## McClellan Air Force Base

Basewide Groundwater Operable Unit

# Groundwater Operable Unit Remedial Investigation/ Feasibility Study Report

**SUBJECT:** Groundwater (GW) Operable Unit (OU) Final Remedial Investigation/Feasibility Study (RI/FS) Document

**FIGURE E-2**  
**MOST RECENT SAMPLING DATES**  
 FOR ZONE B MONITORING WELLS  
 GROUNDWATER OPERABLE UNIT RI/FS  
 McCLELLAN AIR FORCE BASE  
 SACRAMENTO, CALIFORNIA

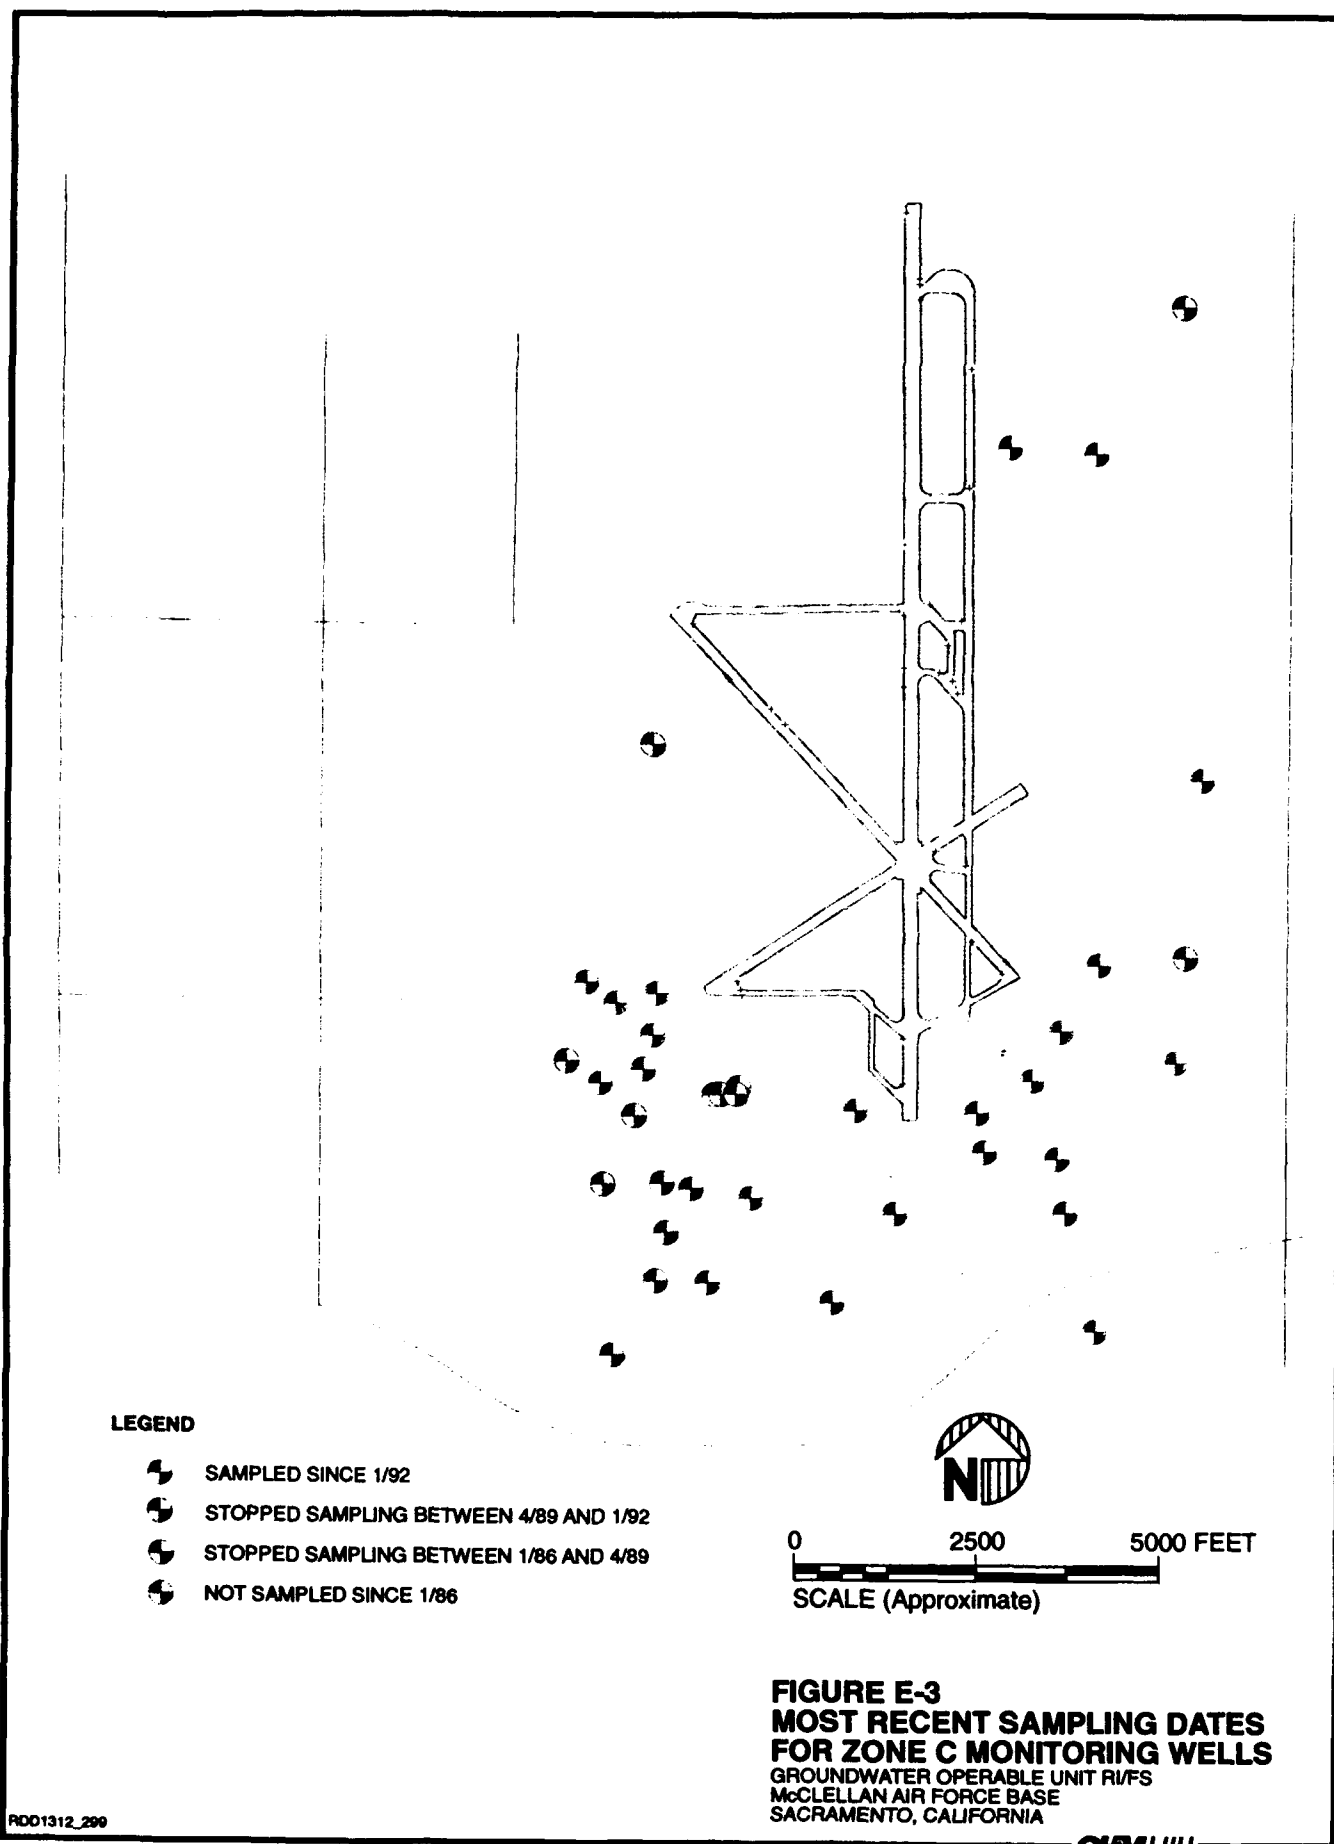
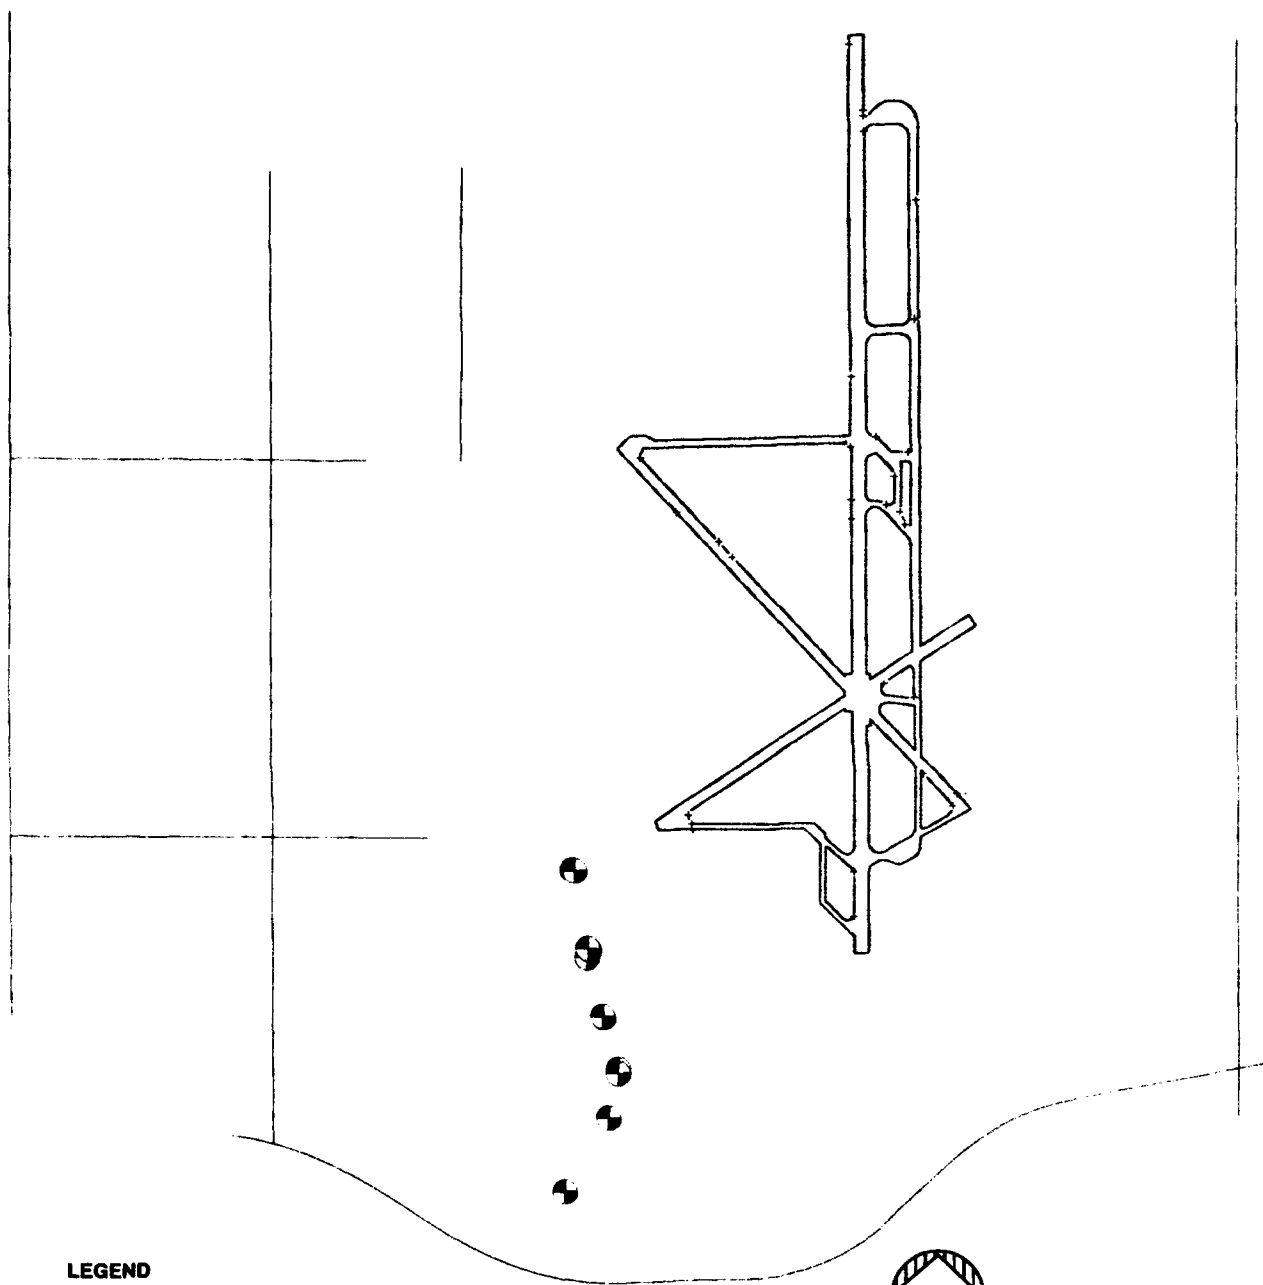
- c. Page E-1, paragraph 2. It is stated that Figures E-2 and E-3 suggest that fewer B and C Zone monitor wells have been dropped from the monitor program. That is likely due to the fact that none of those wells have gone dry and many were recently added during plume definition and PGOURI development. They were likely added in spots that necessitated continued monitoring.**
